| FOREST LAKES FILING NO. 5, 6 & 7 GRADING INDEX REFERENCE SHEET | | | |
| PRE-DEVELOPMENT GRADING AND EROSION CONTROL PLAN | | | |

| FOREST LAKES FILING NO. 5, 6 & 7 | | | |
|--|--------------|--------------|---------------|
| PRE-DEVELOPMENT GRADING AND EROSION CONTROL PLAN | | | |

| DRAWN BY | BB | (H) 1" = 50' | SHEET 7 OF 13 |

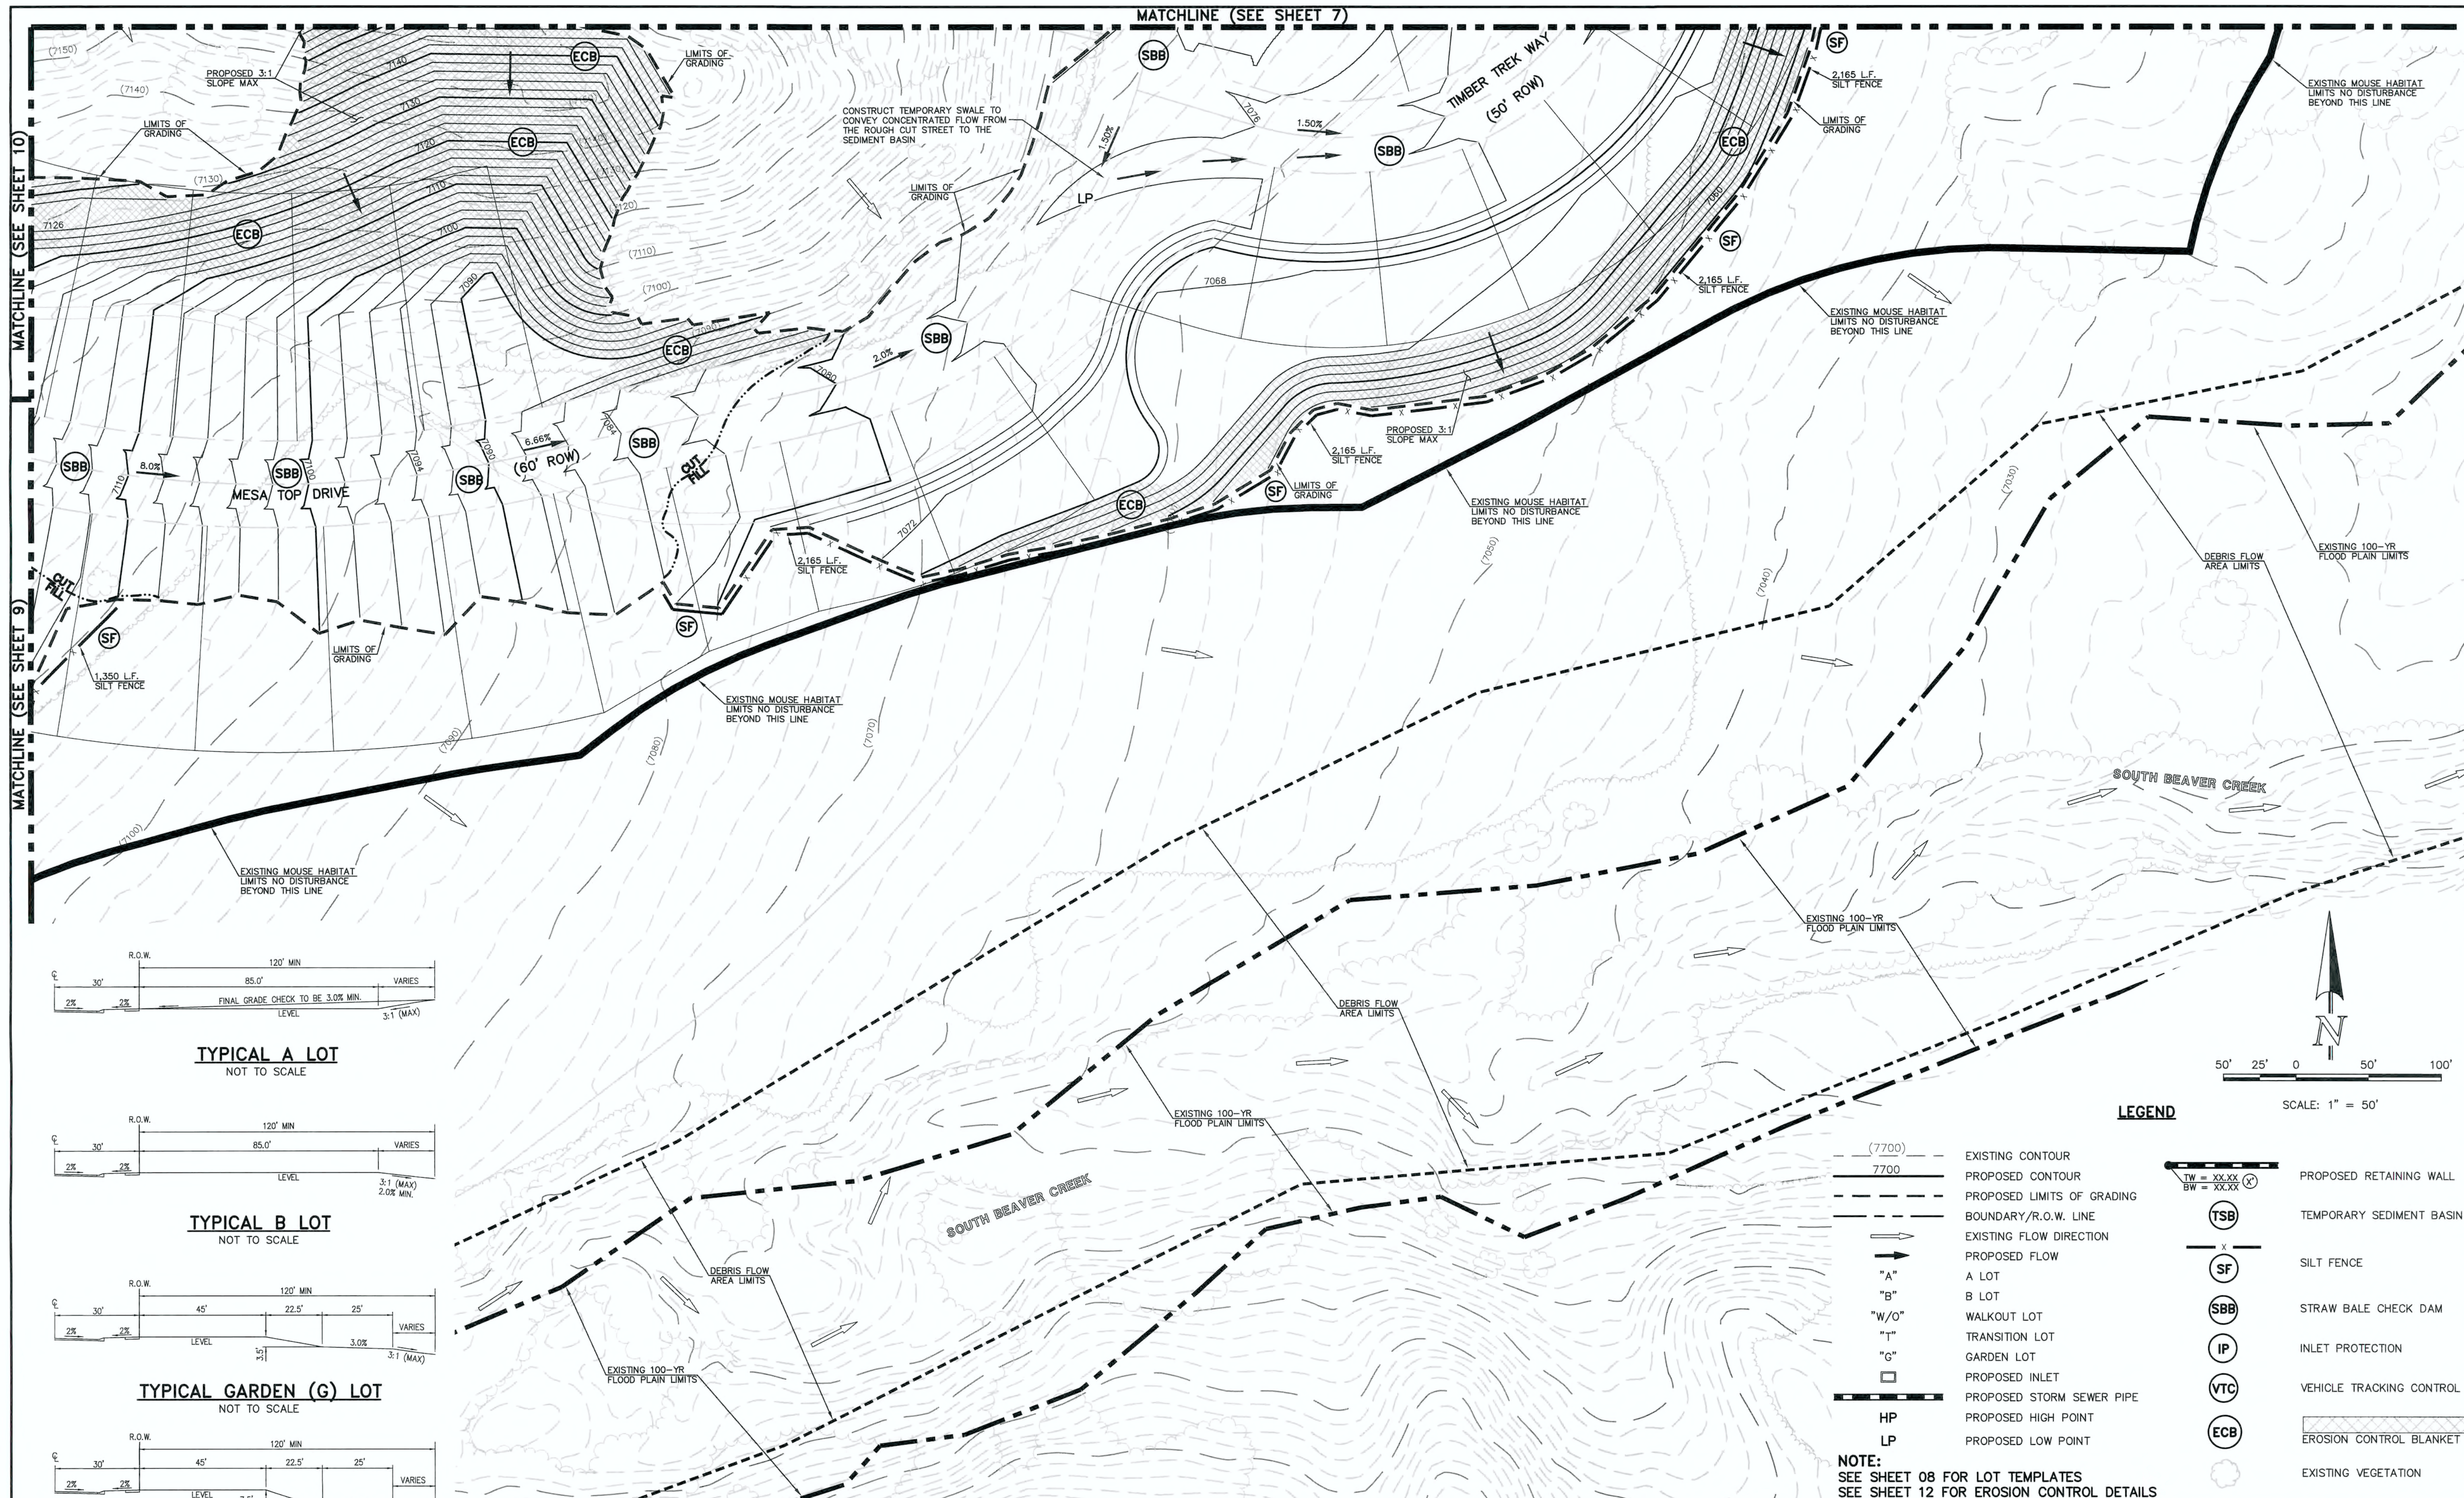
Provide detailed information (note or detail drawing) regarding the temporary swale: side slope, min/max slope, min depth, lining (grass or ECB or riprap), etc.

Provide detailed information (note or detail drawing) regarding the temporary swale: side slope, min/max slope, min depth, lining (grass or ECB or riprap), etc.

| DRAWN BY | BB | (H) 1" = 50' | SHEET 9 OF 12 | |

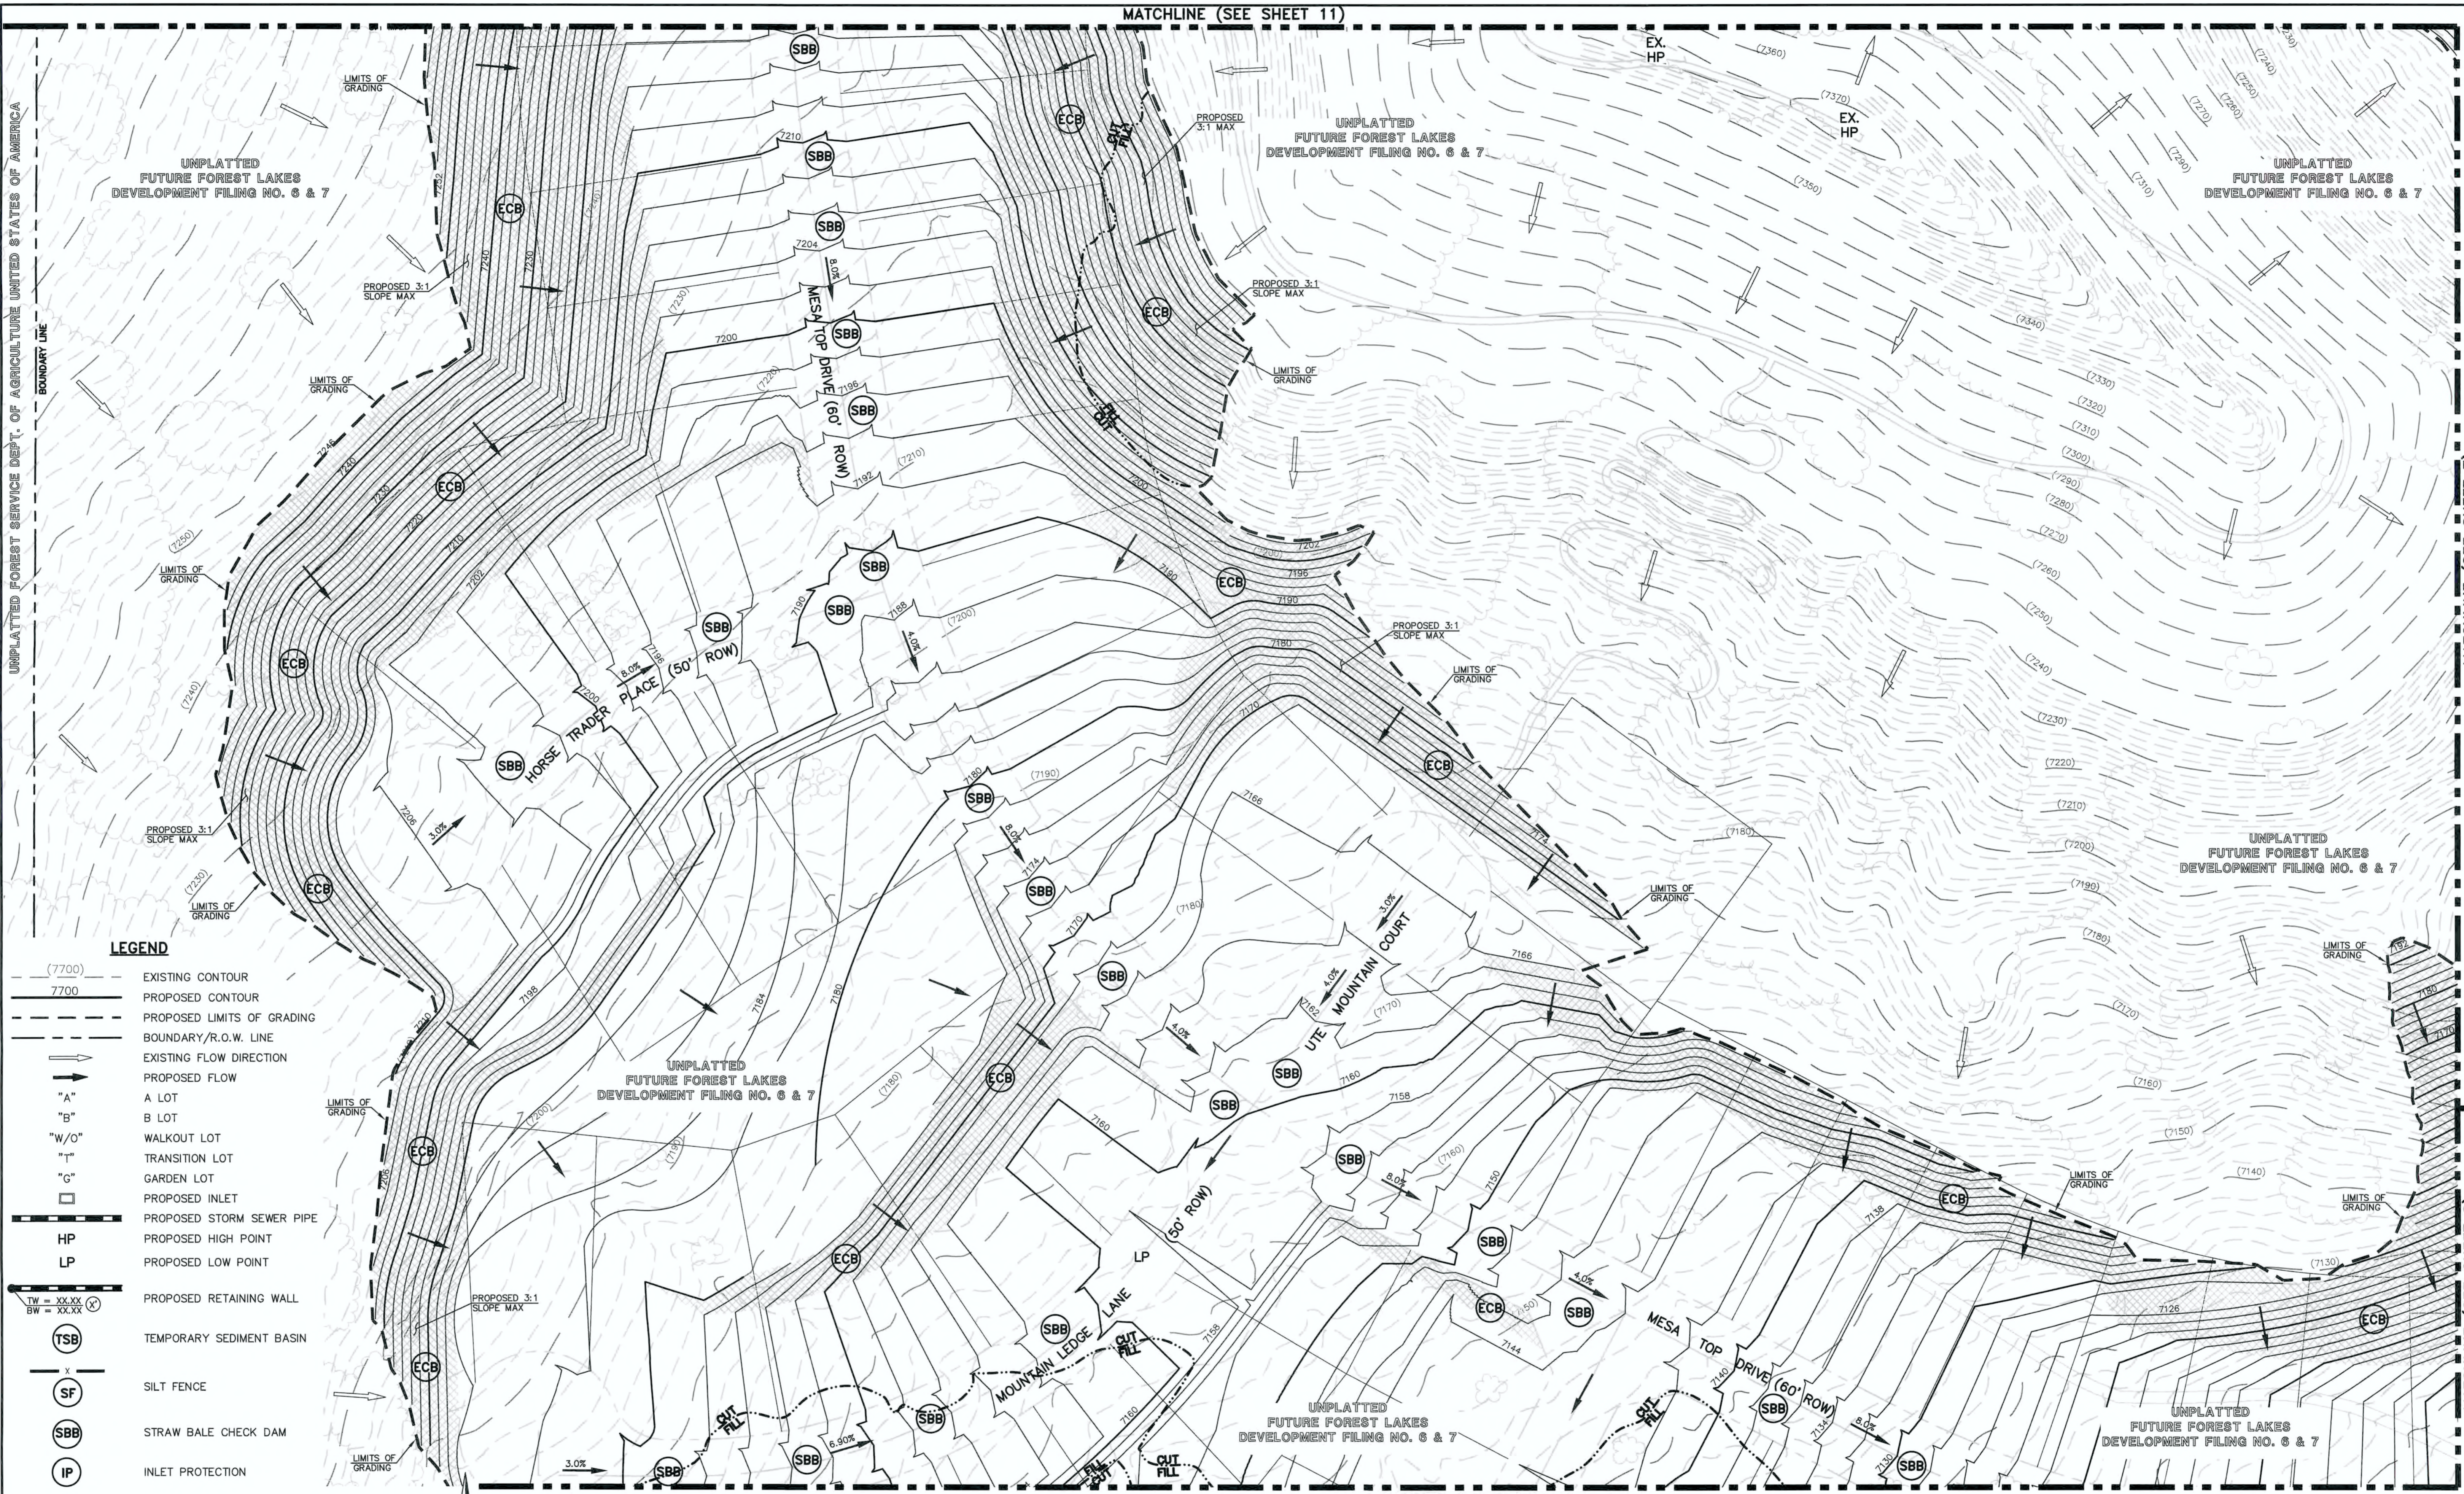
Provide detailed information (note or detail drawing) regarding the temporary swale: side slope, min/max slope, min depth, lining (grass or ECB or riprap), etc.

Provide detailed information (note or detail drawing) regarding the temporary swale: side slope, min/max slope, min depth, lining (grass or ECB or riprap), etc.
